FIELD CHANGE ORDER	NUMBER: DS-650Q2-F001
--------------------	-----------------------

FCO DS-650Q2-F001

INTERCONNECTION OF MIRA MODULES (SYSTEM A only is shown)

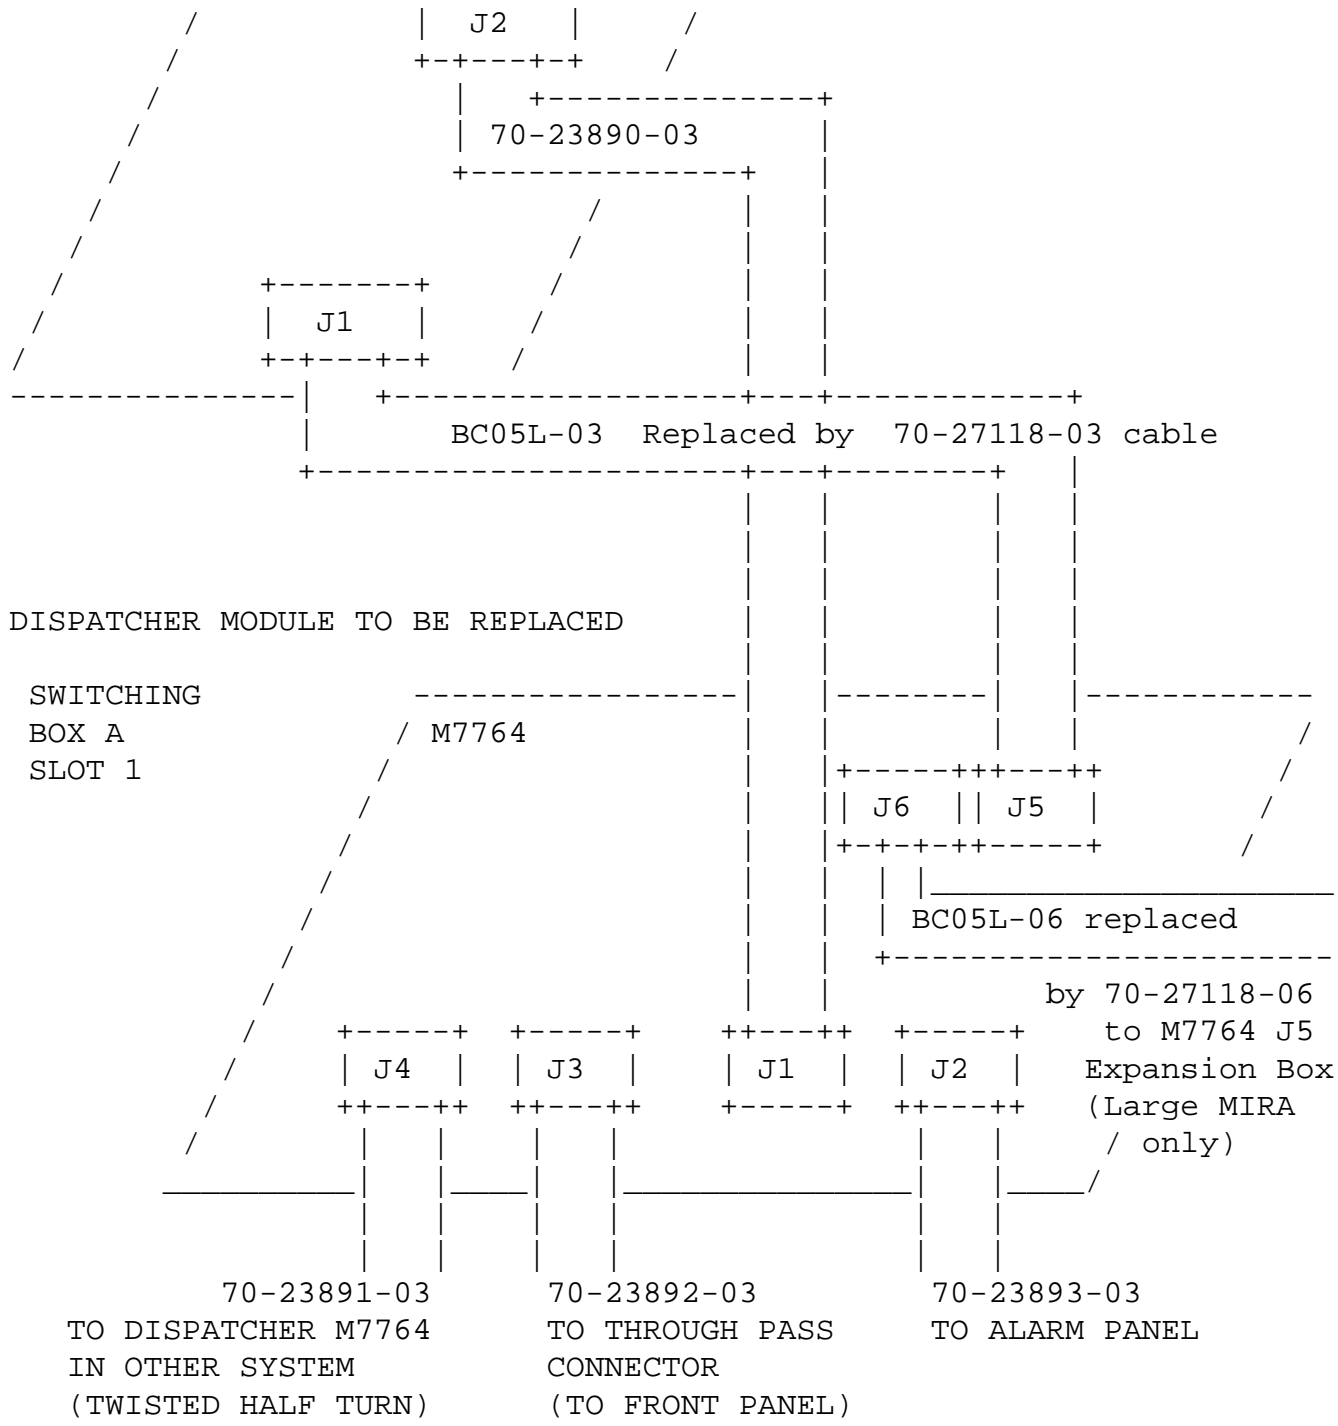
WATCH DOG MODULE TO BE REPLACED

COMPUTER A  
CPU BOX SLOT 3

This FCO replaces all watch-dog, dispatchers modules and BC05L cables attached to these dispatchers. This replacement requires the complete MIRA to be powered down.

The interconnection of the modules and cables to be replaced is shown on Page 4.

Replace all modules M7763 and M7764 at Revision D or below by new modules at Rev. E and replace BC05L dispatcher cables at one time.
